# **Final Monitoring Report/Closeout Report**

Pee Dee Stream Restoration Project  
NCDMS Contract No.: 004644  
NCDMS Project No.: 95350  
USACE Action ID: SAW-2012-01077  
DWR #: 13-1140

RE: Pee Dee Stream Restoration Site: MY7 Monitoring Report (NCDMS ID 95350)

Listed below are comments provided by DMS on November 22, 2021 regarding the Pee Dee Stream Restoration Site: Year 7 Monitoring Report and RES' responses.

# MY7 2021 Pee Dee Dale 1 Flow Gauge

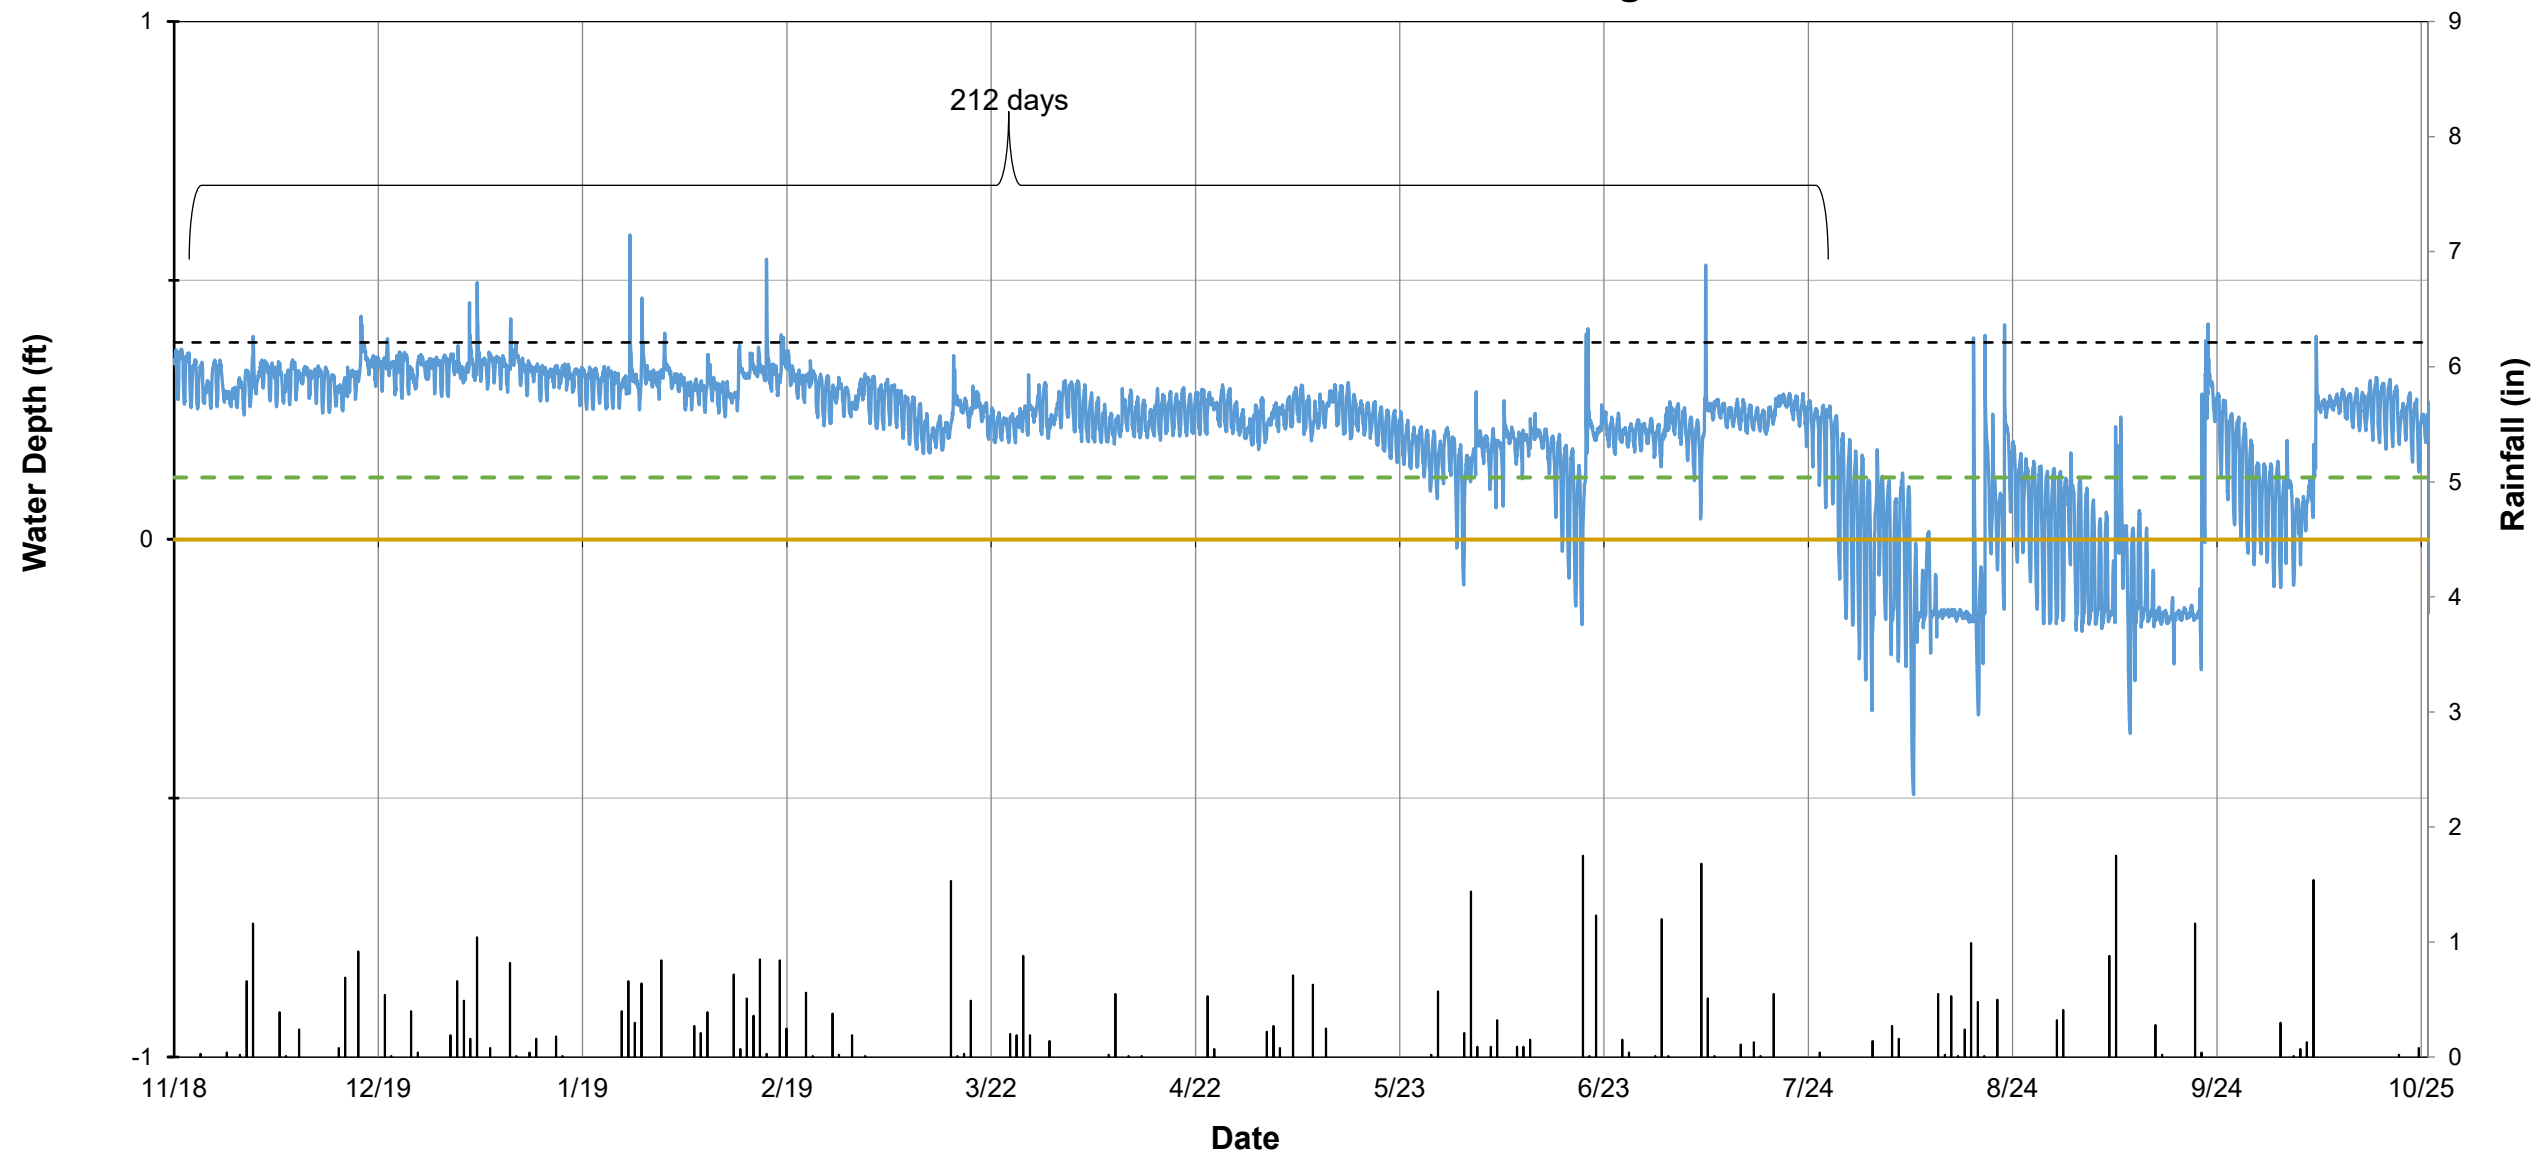
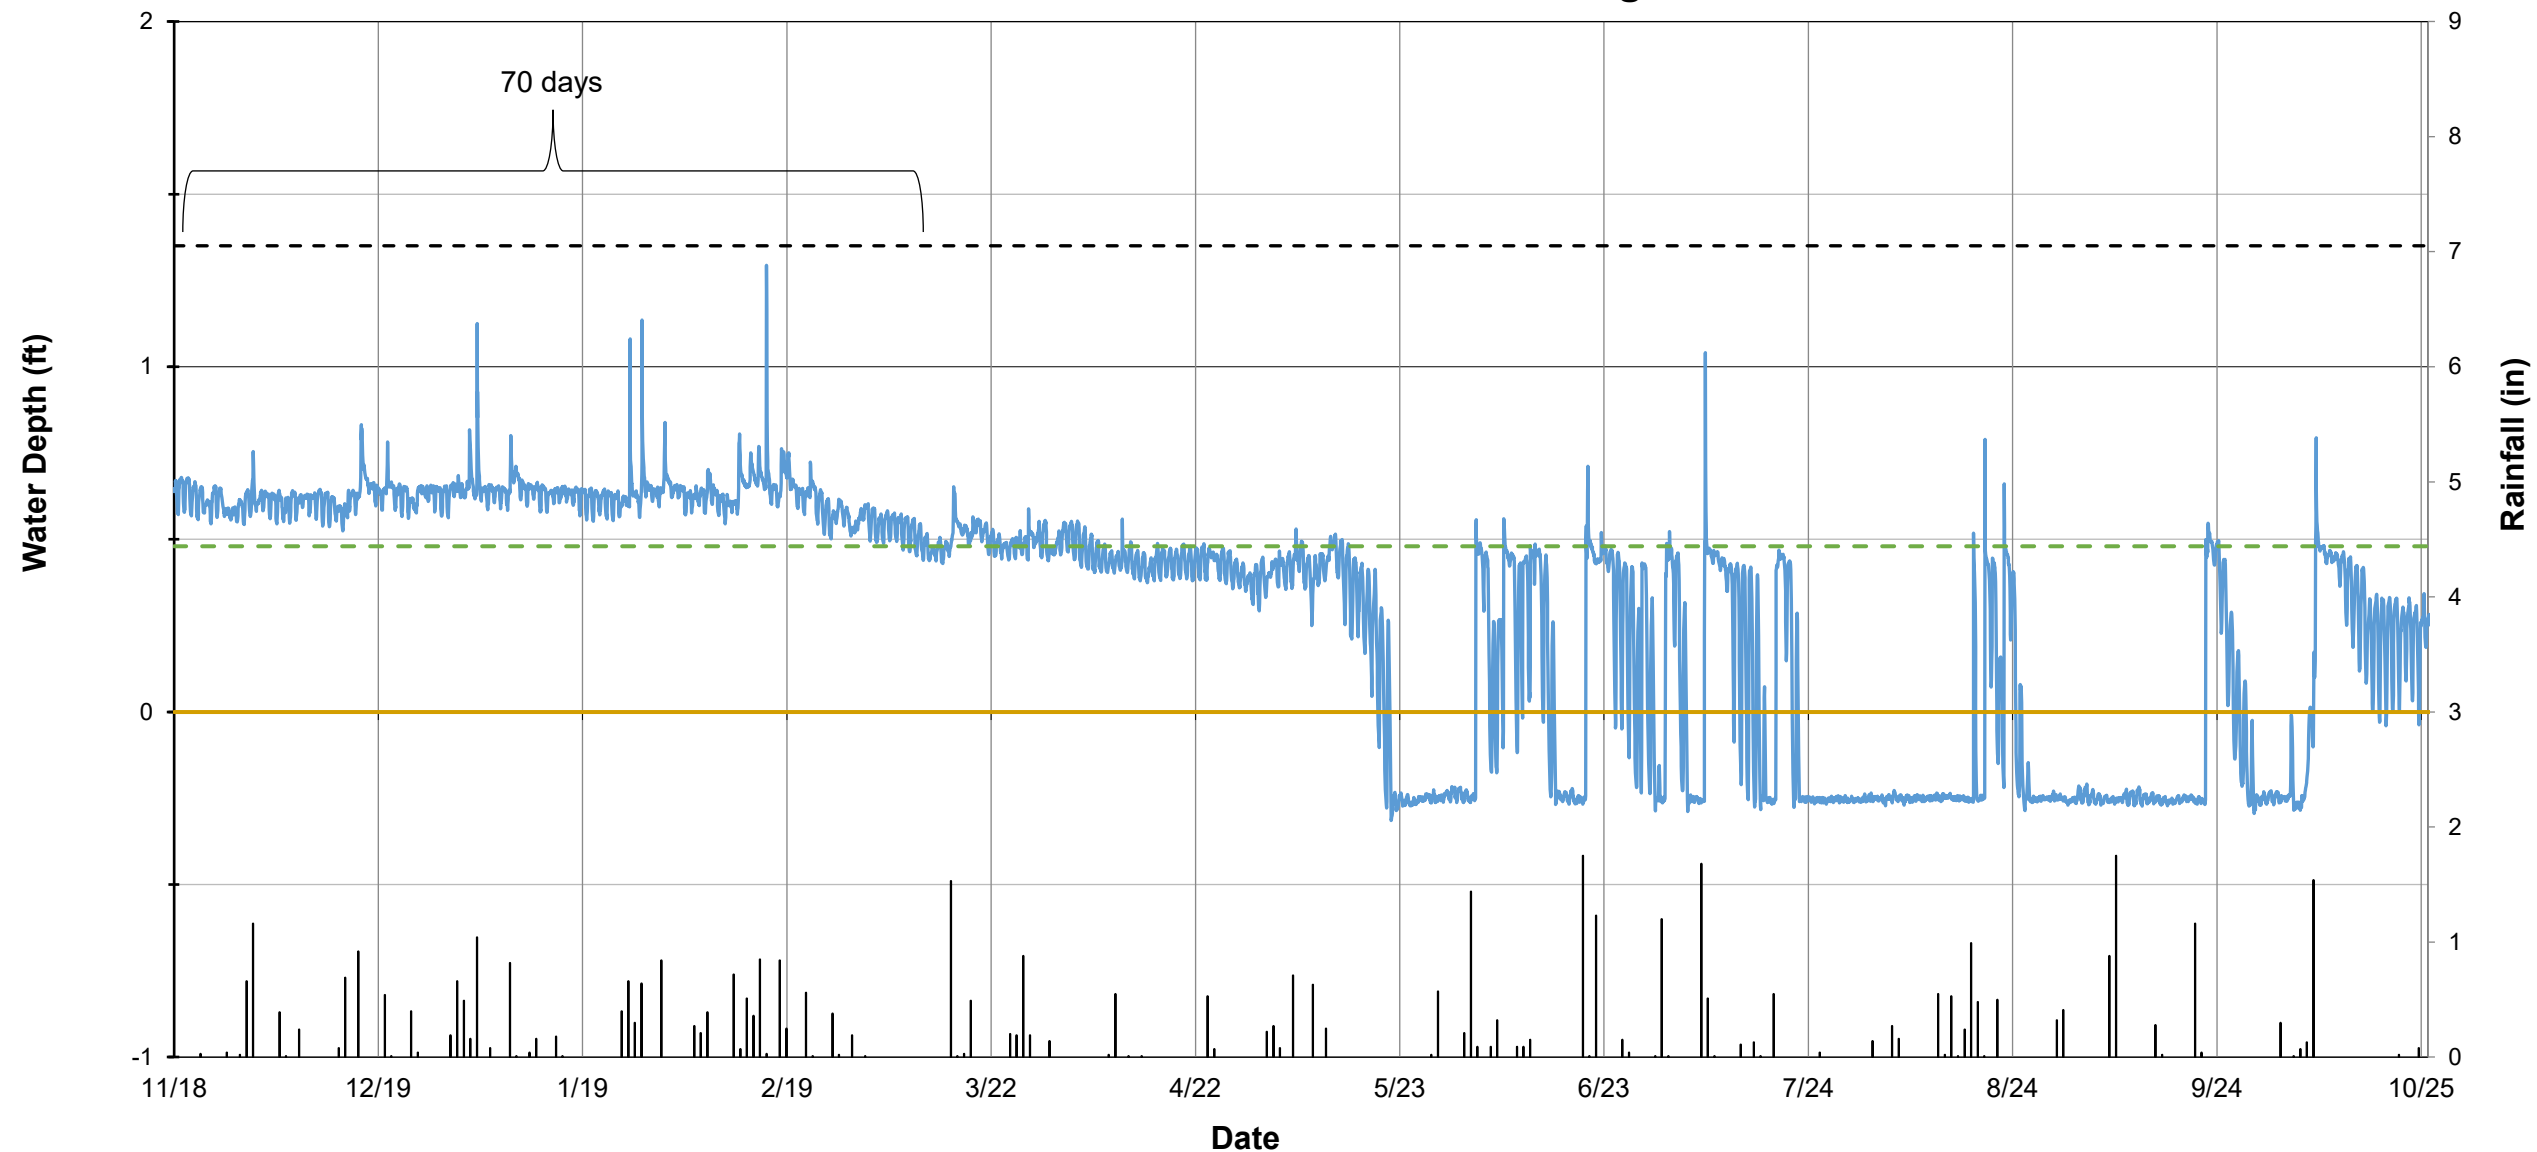
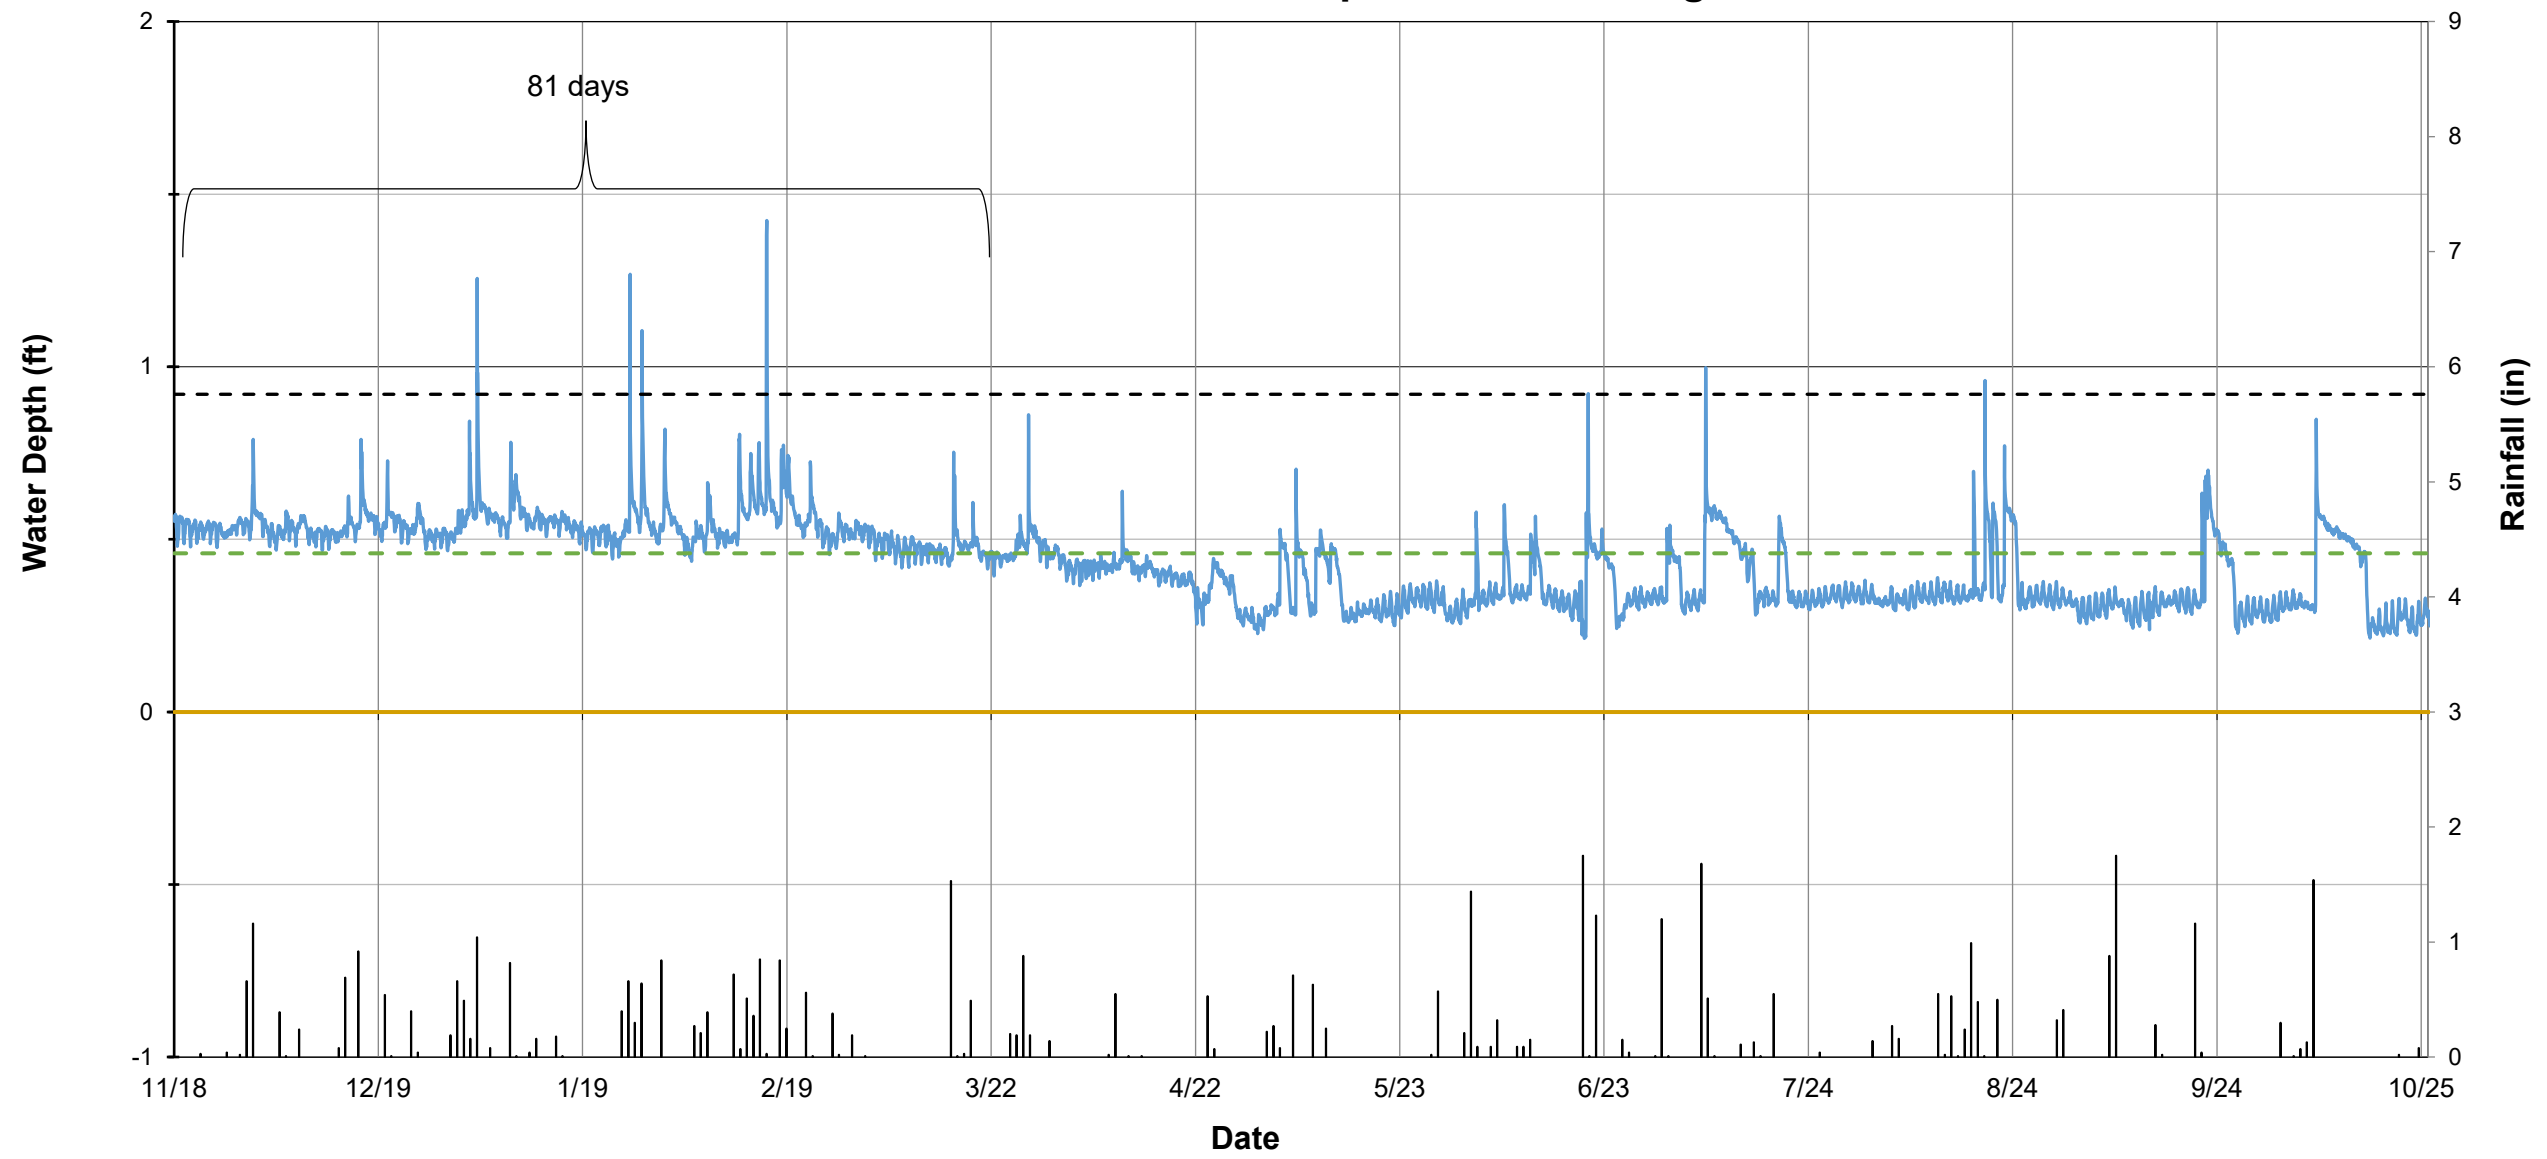
Please indicate the consecutive days of flow on the flow gage graph, and if possible show the corresponding period on the graph.

- Ensure that excel flow gauge figures are being displayed correctly. The chart type should be scatter with straight lines.  
Done.

Done.
